Ansty Garden Community: Flood Risk Assessment and Outline Drainage Strategy

P25035_R2_Rev2
September 2025

Document reference	Issue date	Comments	Written by	Approved by
P25035_R2	May 2025	Final	JEM	MJF
P25035_R2_Rev1	August 2025	Final (following LLFA feedback)	JEM	MJF
P25035_R2_Rev2	September 2025	Final (following further LLFA feedback)	JEM	MJF

This report has been revised/updated based upon feedback received from the Lead Local Flood Authority in August 2025. The following table itemises all comments raised and the revisions that have been made to address each point.

Figure 7-2 Watercourse crossing (soffit) and flood risk elevation cross-sections

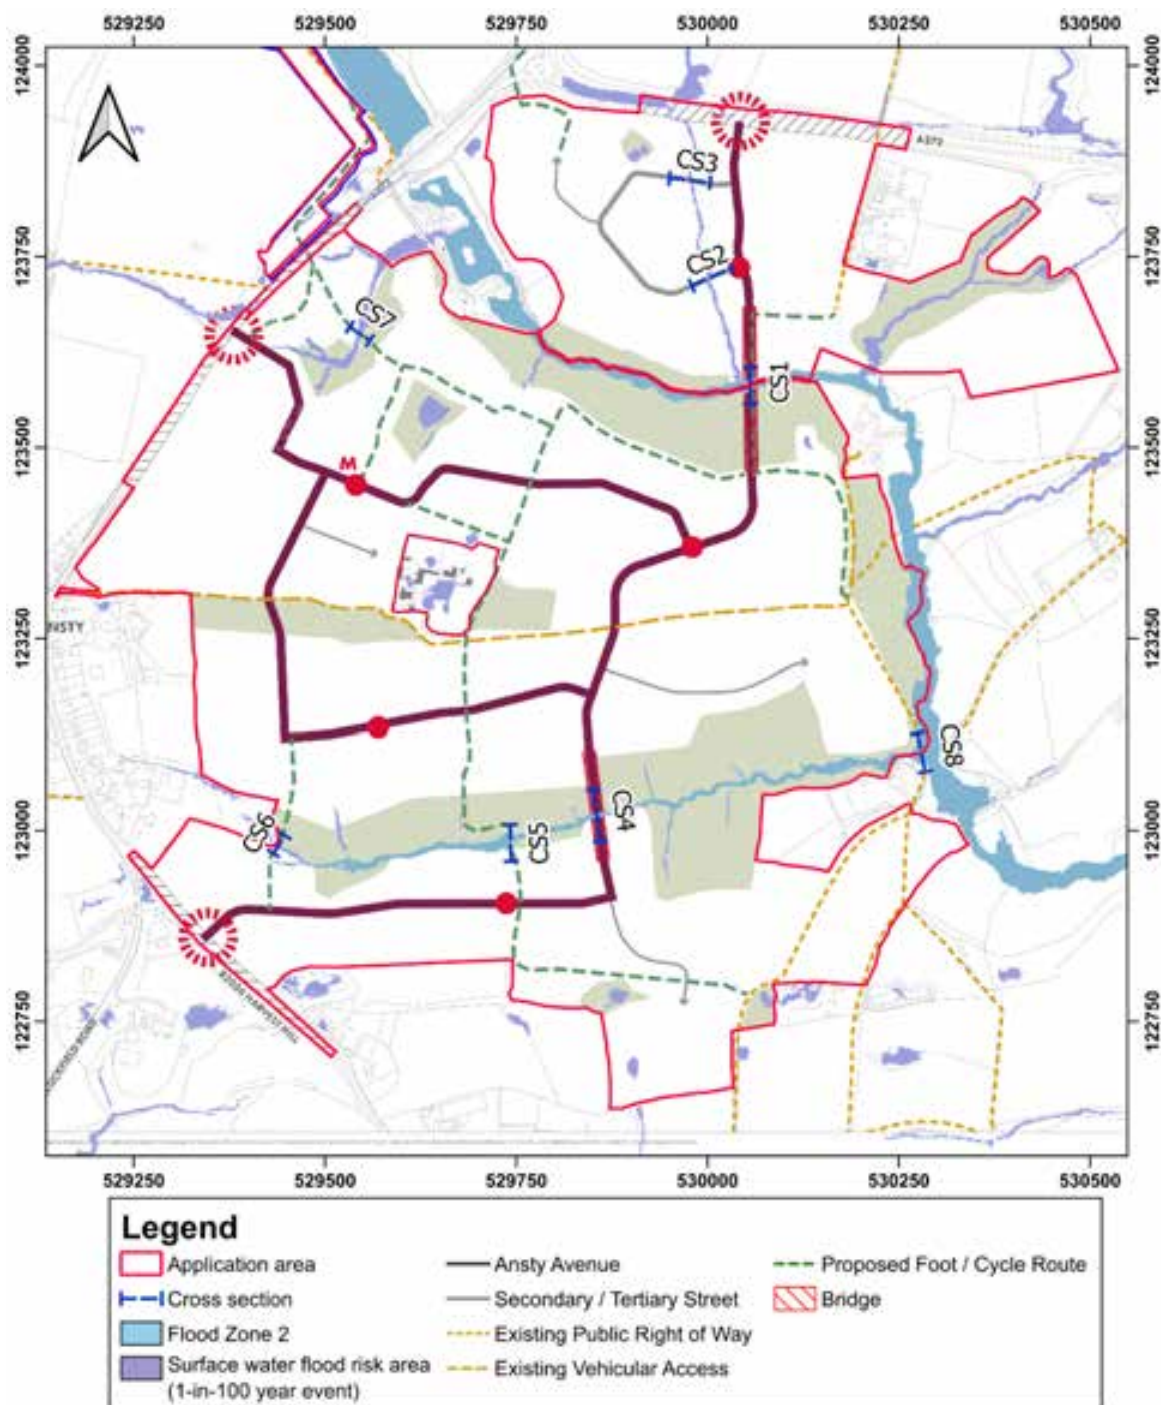
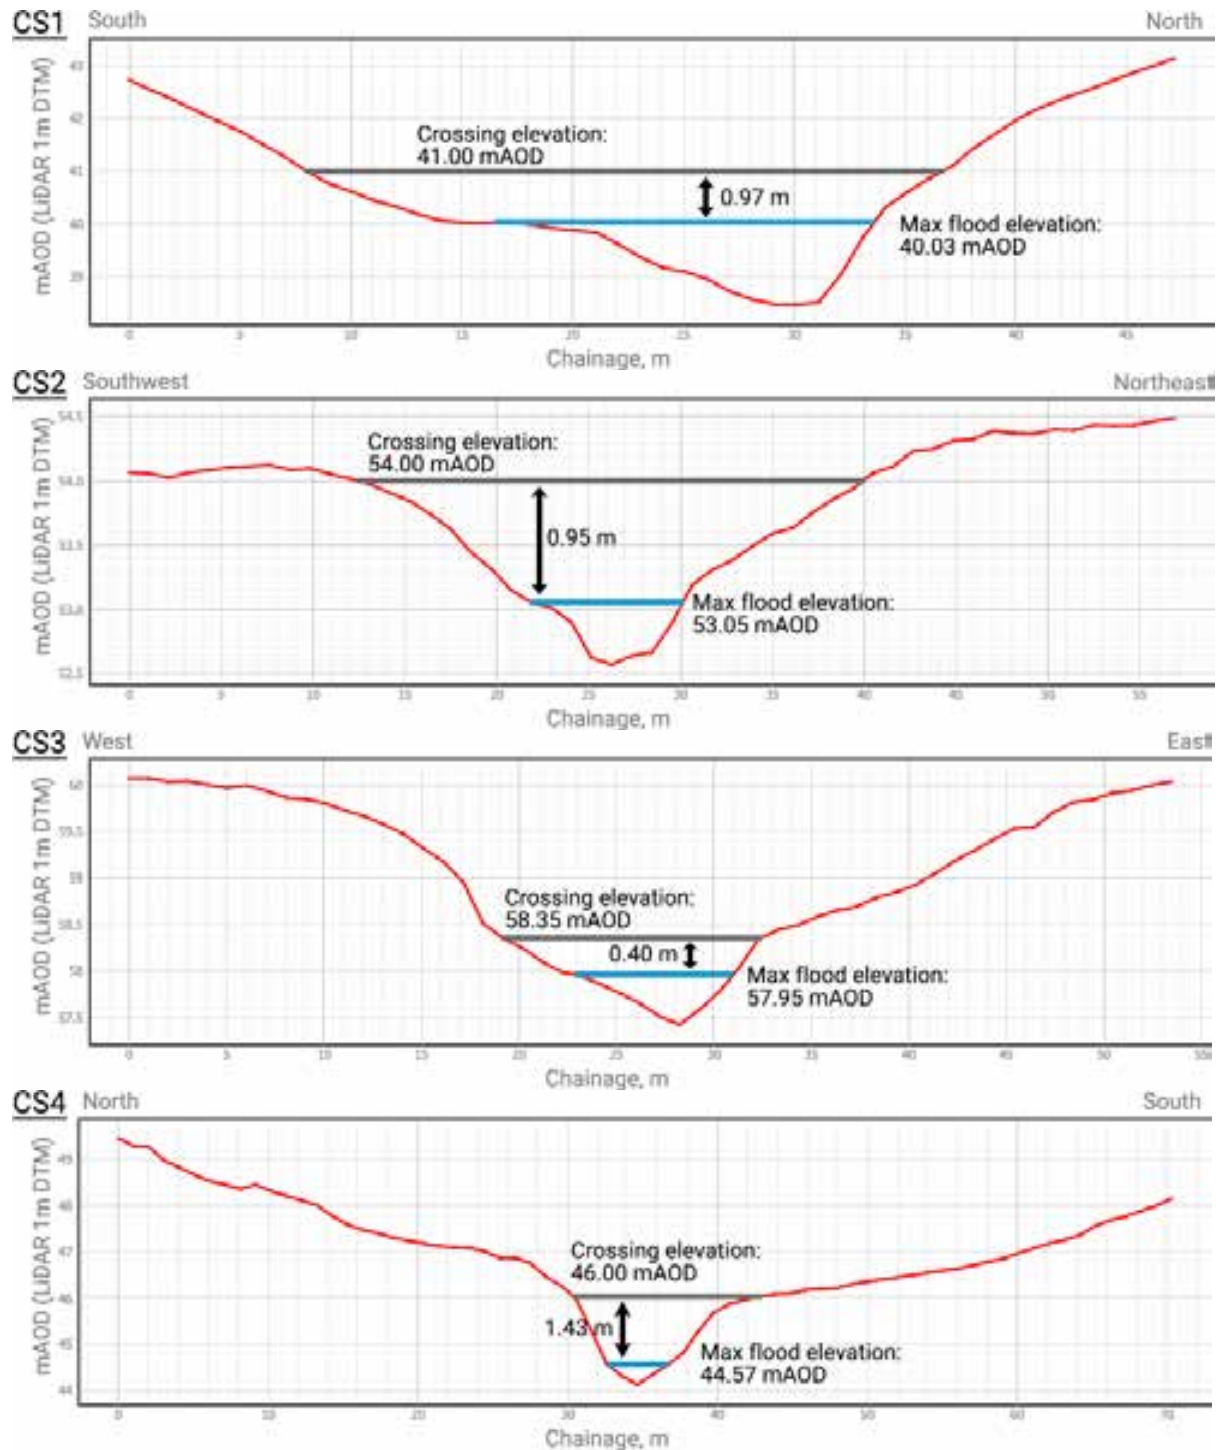
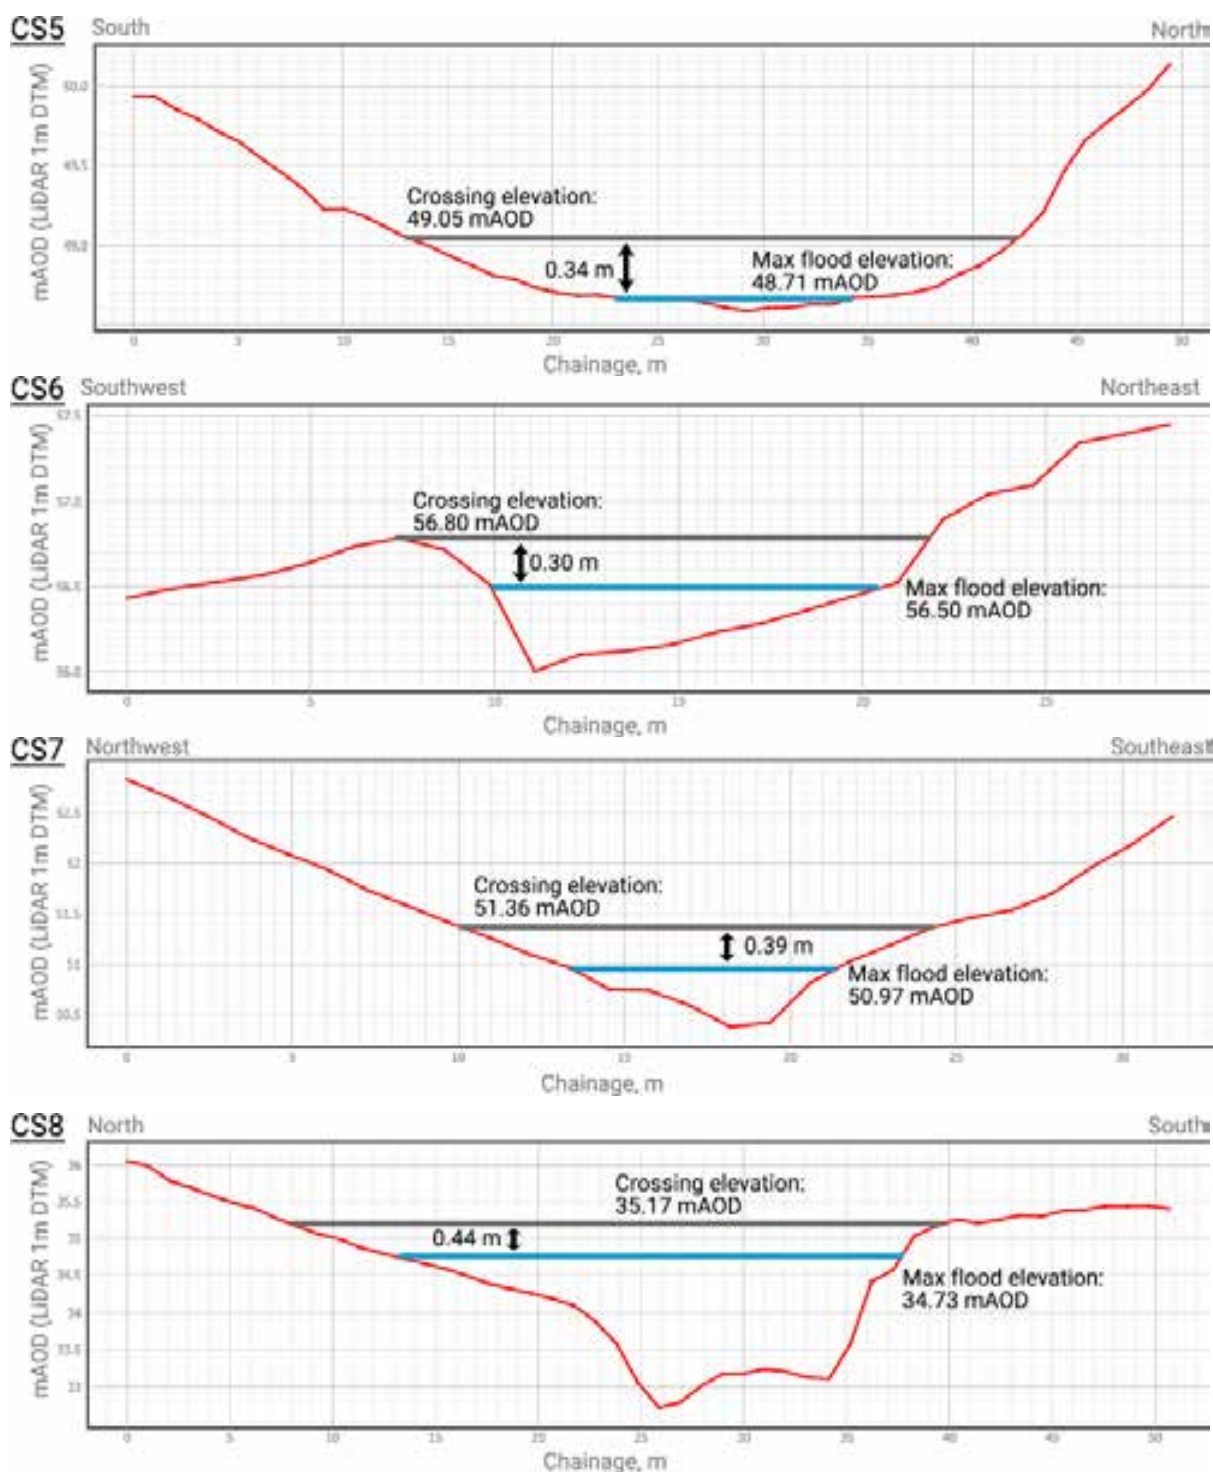
8. The FRA and Drainage Strategy does not cover how the site will remain safe in times of flooding. As mentioned previously, due to the impact crossing heights can have on surrounding development layouts and proposed site levels it is important this is considered for all watercourse crossings at this early masterplan stage. This is to ensure that alterations to facilitate safe access/egress do not impact the proposed development description or likely masterplan layout.	Cross sections of the flow path/watercourse intersections, illustrating the ground elevations, flood levels and deck levels of crossings, have been included within Section 7.2 to illustrate that intersections will remain dry and accessible during a flood event. The exercise was also undertaken for areas in proximity to the Copyhold Gill and issued to the LLFA previously.

Figure 7-3 Flood risk and development area overlap areas

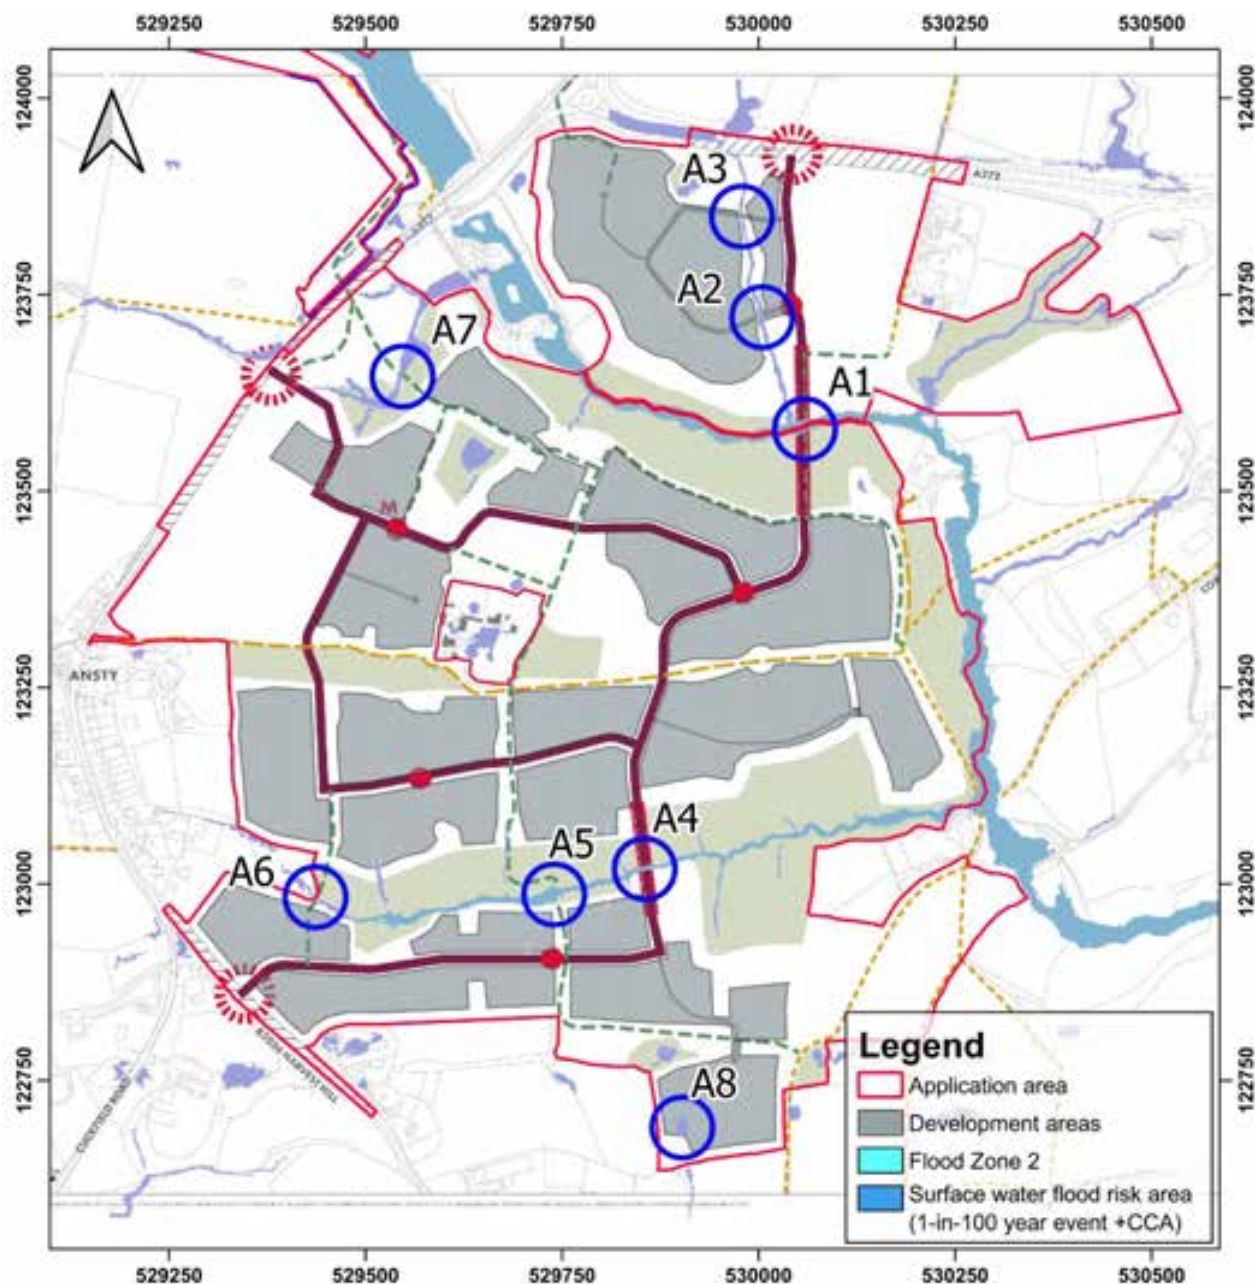
9. We have concerns that there will be a loss of floodplain storage as a result of this development. As mentioned previously, evidence that the impact development could have on floodplain storage, for all sources of flooding has been considered and mitigated against will be required at this stage of planning. This is required at outline application stage due to the potential this could have on developable area on the site and the impact that could have on the development's masterplan.	There is no planned development within the fluvial floodplain area (aside from the bridge crossing as discussed in the FRA). Cross sections at intersections between access routes and surface water flow paths or ephemeral streams have been assessed in Section 7.3 of the report. The crossings will be constructed above the peak flood level, with the crossing utilising open-span style bridge, with no construction within the channels (e.g. no culverts or abutments which may result in a loss of floodplain storage or limit channel flows). . For the few areas of mapped SW flood risk which overlap with development areas (the 1 in 100 year +CCA flooding area in the southern development area), these flood risk areas will not be present post-development owing to the introduction of the drainage infrastructure (i.e. the catchment area will be positively drained, with surface water being directed to the SuDS features rather than ponding on the surface). Calculations have been provided which demonstrate the capacity of the proposed SuDS features to receive and manage runoff within the various site sub-catchments, as well as calculated losses in ponding volume vs volumes provided by representative SuDS features (see Section 7.3).
